**TYPE III DRE DESIGN REVIEW
FINDINGS AND RECOMMENDATION**

REPORT DATE: May 12, 2020

FILE NUMBER: DRE/FSP/TR 20-26000071

PROPOSAL: Type III Design Review E (DRE) and Future Street Plan (FSP), and Type II Tree Removal for construction of a three-story, approximately 96,000 square-foot government business services office building, surface parking area, and associated site improvements with pedestrian and vehicular site access from SE Stark Street and SE 223rd Avenue.

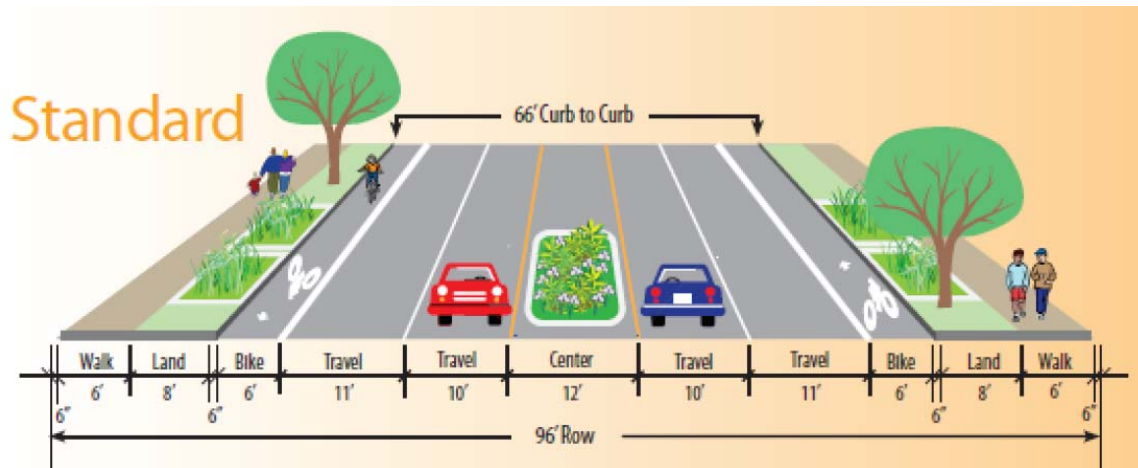
A Standard Arterial cross section is shown below, with an 8-foot planter strip and a 6-foot sidewalk. On SE Stark Street the applicant is showing a 6-foot sidewalk and a planter strip with street trees in the drawings. The planter strip is as close to standard as possible with the modifications required by the right-turn lane. The proposed frontage design is acceptable to

Transportation Engineering and no design modification is required as the planter strip design changes are due to a City intersection project.

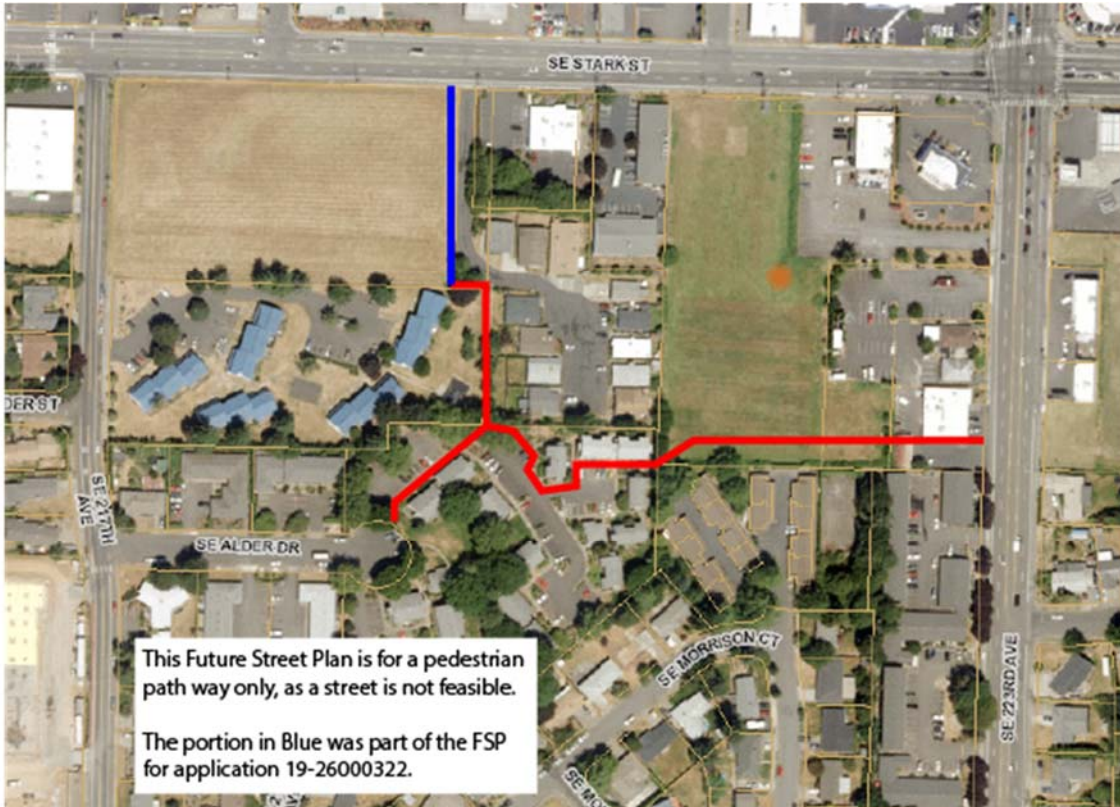
The applicant has proposed street access on both frontages, which is allowed for a corner property with two frontages. The developer has provided a traffic impact analysis (TIA) to evaluate the safety of these two proposed driveways. The TIA determined that a full-access driveway to SE 223rd Avenue would be safe, but that the driveway to SE Stark Street was too close to the intersection to allow for full access, so turns will be limited to right-in, right-out.

The proposed porkchop island may be retained at the Stark driveway, but the applicant should be aware that the City may, in the future, supplement it with a median barrier to further prevent left turns out of the driveway.
